PLANNING APPLICATION PLN-19-0017

SMITH STREET (BETWEEN WELLINGTON STREET AND GEORGE STREET), LONGFORD

Traffic Comment

Street Improvement Works (Street Trees, Medians)
Smith Street Longford, Tasmania

NOTE: Development approval sought only between Wellington Street and George Street (February 2019).

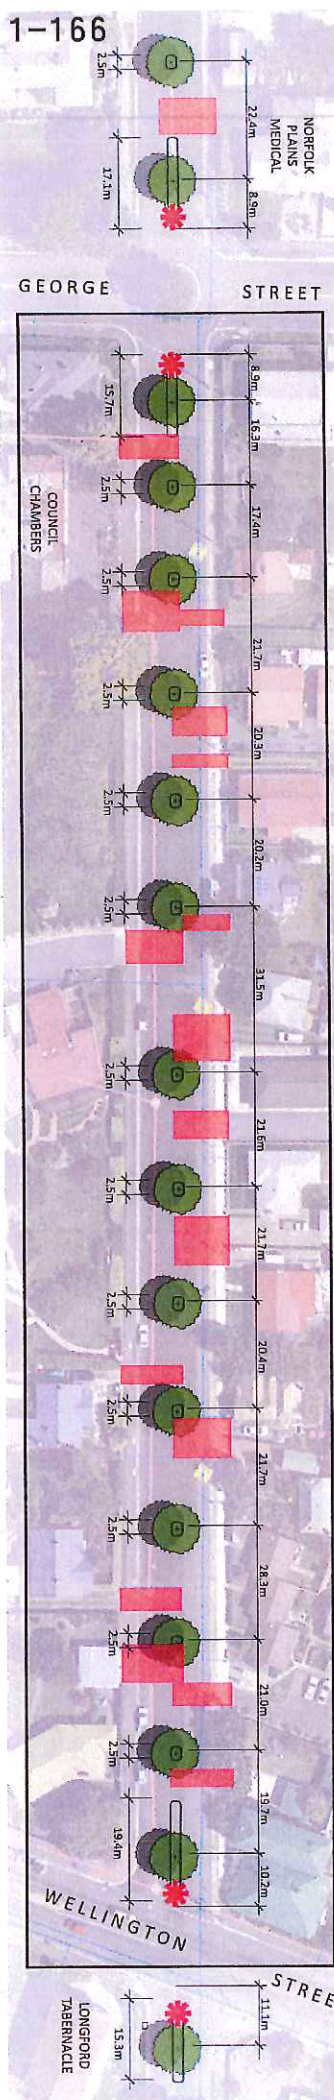
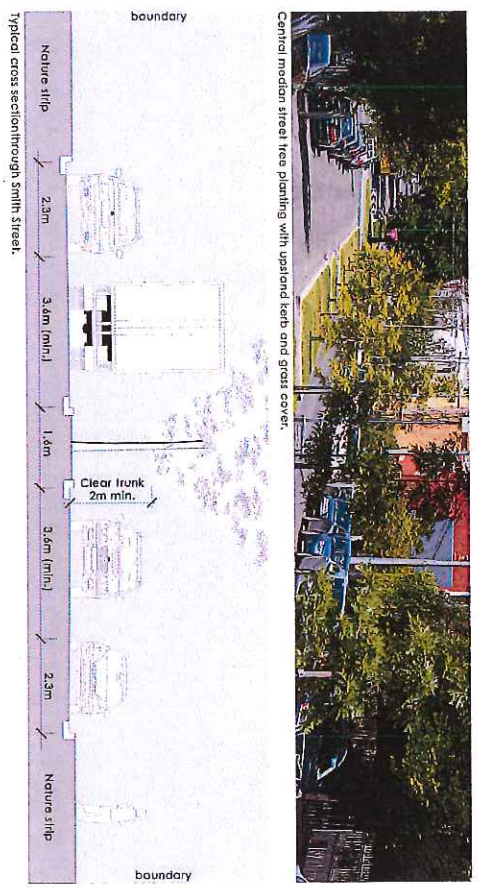
UPDATE Rev B1 – *general review of the updated final plans provided (attached) show some locations of trees as proposed which may provide some potential issues for vehicle turning movements in some cases, depending on final tree and kerb/tree surround placement. This should be reviewed further by Council either during detailed design with turning template overlays on the drawing file to confirm traffic movements can still occur, or during site set out of the works and in consultation with landowners to confirm specific suitability. It is likely that suitable site locations for tree centres can be established similar to that shown, but this should be confirmed prior to final set out on site.*

UPDATE Rev B1 – general review of pedestrian crossing points in the final plans shows that pedestrian crossings via medians/pedestrian refuge sites is likely appropriate to service this section of Smith Street (between George and Wellington), however as noted above a specific crossing for the possible desire line directly outside the Council Chambers entry could still be further considered by designers/Council.

The updated Stage 1 plans for the section between George and Wellington Streets provides no additional issues, however turning movements with specific tree location should still be further reviewed by Council as noted.
